19801 DARNESTOWN ROAD, BEALLSVILLE
CASE # 17/01-13A (DARBY STORE
BEALLSVILLE HISTORIC DISTRICT)

SUBJECT: STAFF ITEM – 19801 DARNESTOWN ROAD, BEALLSVILLE HISTORIC DISTRICT (DARBY STORE)

9/29/14
 DARBY STORE
 GRADING REVISIONS
 (M-NOPPC) 03' 5" 10'
 1"=10'-0"

REHABILITATION OF DARBY STORE

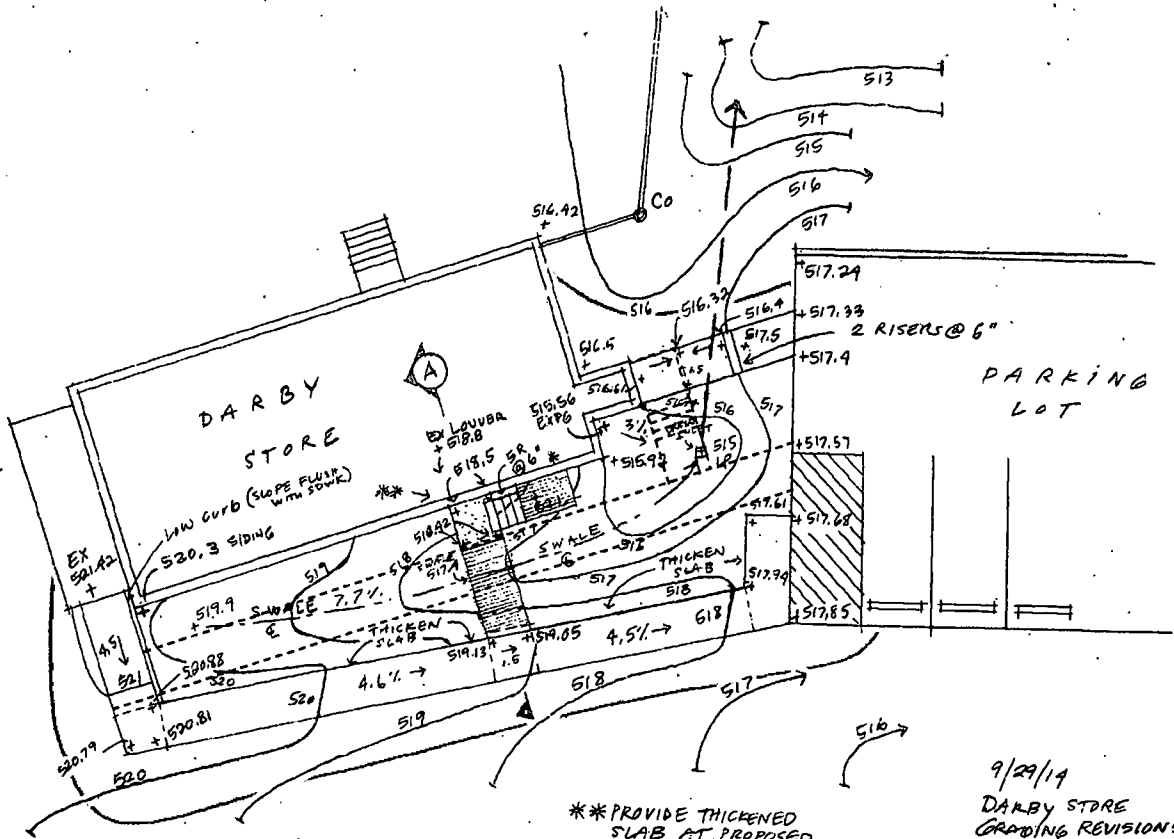
1. Construction of swale along east elevation to channel runoff –prevent water infiltration into foundation.
2. ADA accessible sidewalk shifted slightly to make for construction of swale.
3. Construction of path to main entrance on east elevation. Path will utilize an elevated wood section to bridge the proposed swale.
4. The east and west elevation stair-rails will receive vertical pickets, as the fall height exceeds 30" – material and design of vertical pickets to match what was approved previously (HAWP #627867).

RECOMMENDATION: Staff supports this change and, respectfully, recommends that the Historic Preservation Commission allow this change to be approved at the staff level. The installation of the swale, the sidewalk, and the path will provide a solution to the water infiltration issues and the installation of vertical pickets will alleviate code compliance issues. These alterations will not result in detriment to the Darby Store, the Darby Store's environmental setting, or the Beallsville Historic District as a whole.

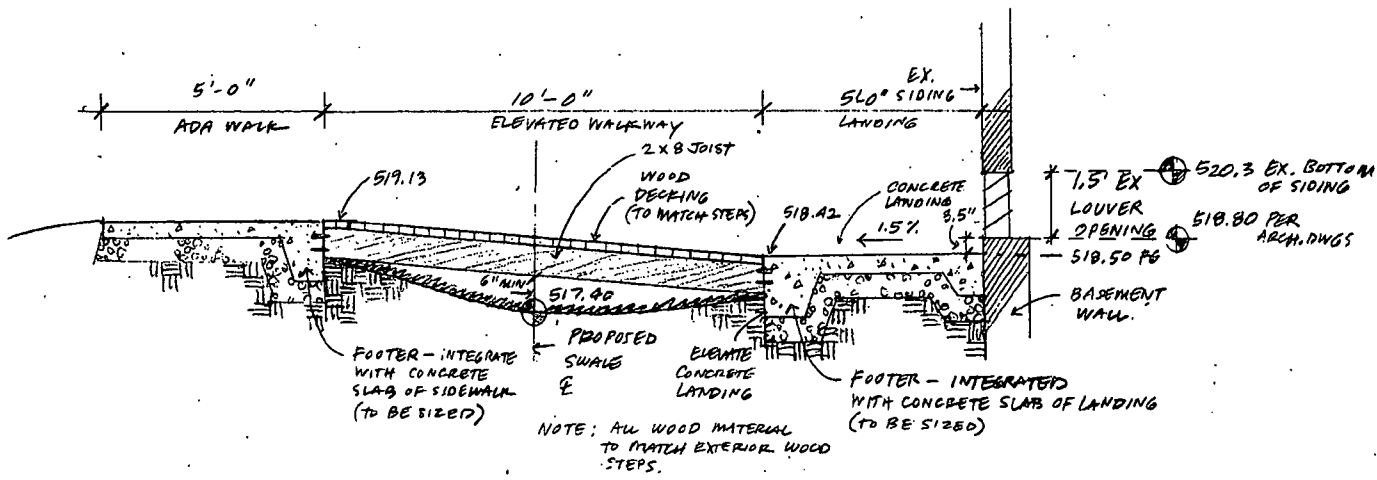
--- Previous pathway layout

- ** PROVIDE THICKENED SLAB AT PROPOSED CONCRETE LANDING
- * BOTTOM PERCO PIPE (CLAMP) AT 518.06 ELEV.
